# Rezoning Transportation Analysis

Petition Number: 2018-146

Date	Description
12-19-18	First Review

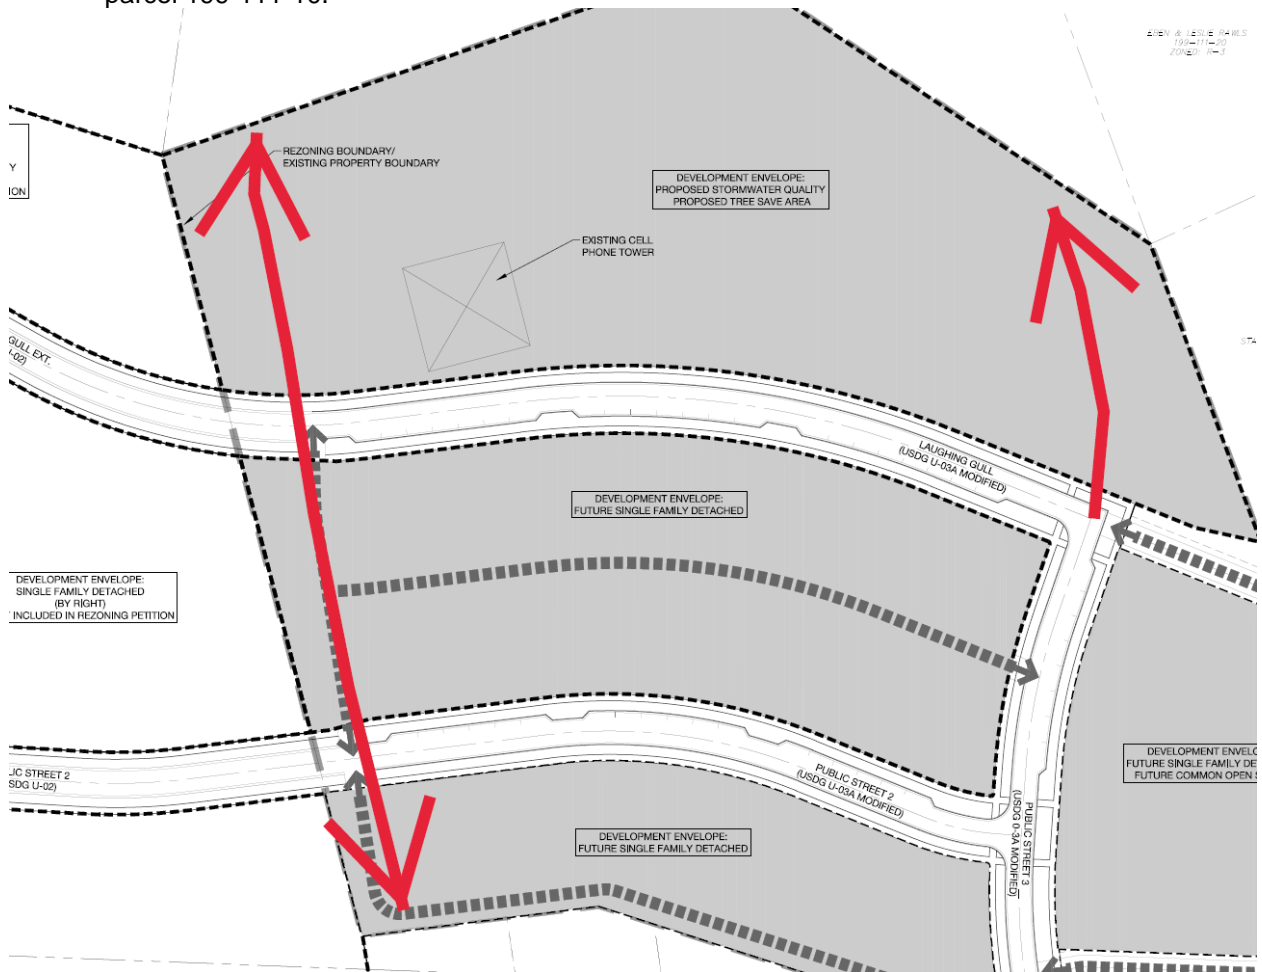
1. **Traffic Study** A Traffic Impact Study/Transportation Technical Memorandum is not necessary for the complete review of this petition.
2. The petitioner should revise the site plan and conditional note(s) to show and commit to constructing 2'-6" curb and gutter on Shopton Road West along the frontage of parcels 19911103 and 19911106. The back-of-curb is located 32.5 feet from centerline of the road. The site plan needs to label and dimension the back of curb from the centerline.

3. The petitioner should revise the site plan and conditional note(s) to show and commit to 6-foot sidewalk on Shopton Road West along the frontage of parcels 19911103 and 19911106. The front of the sidewalk is located 51 feet from centerline of the road. The site plans needs to label and dimension the sidewalk.
4. Shopton Road West has a future right-of-way of 126 feet. The petitioner should revise the site plan and conditional notes to show the dedication of right-of-way, fee simple, of 63 feet from centerline of the road.
5. The petitioner should revise the site plan and conditional note(s) to commit to constructing an East-West "Local Residential Wide" Street.
  - a. The petitioner should revise the site plan and conditional note(s) to commit to extending a "Local Residential Wide" street from Laughing Gull and Public Street 3 intersection north to parcel 199-111-10.

6. The petitioner should revise the site plan to add a note specifying dedication and fee simple conveyance of all rights of way to the City before the site's first building certificate of occupancy is issued. CDOT requests right of way set at 2' behind back of sidewalk where feasible.
7. The petitioner should revise the site plan to add a note specifying all transportation improvements will be approved and constructed before the site's first building certificate of occupancy is issued. The
